Technical product information

Transaction No.: 2026513/8

Engine: rattling noises from front/engine compartment when starting engine

Release date: 02-Jul-2013

Illustration 3) green circles = timing chain protection cover

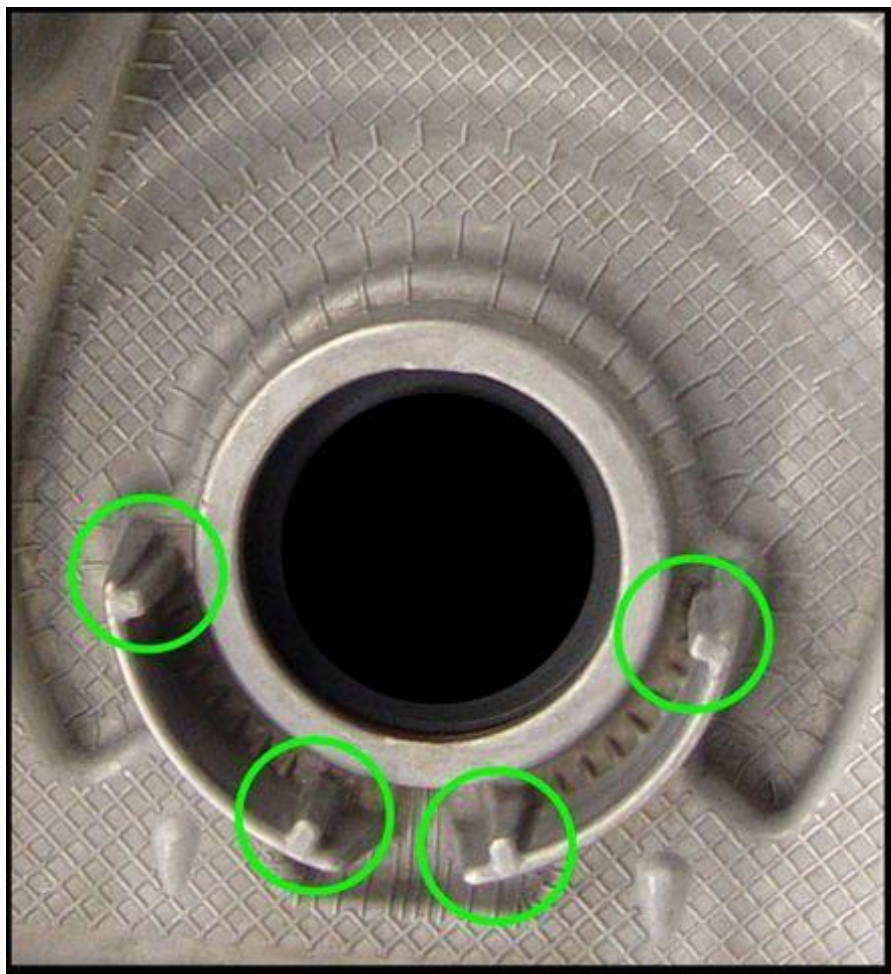
Check chain box:

Check whether a guard for the timing chain available is fitted on the chain box (illustration 4, green areas).
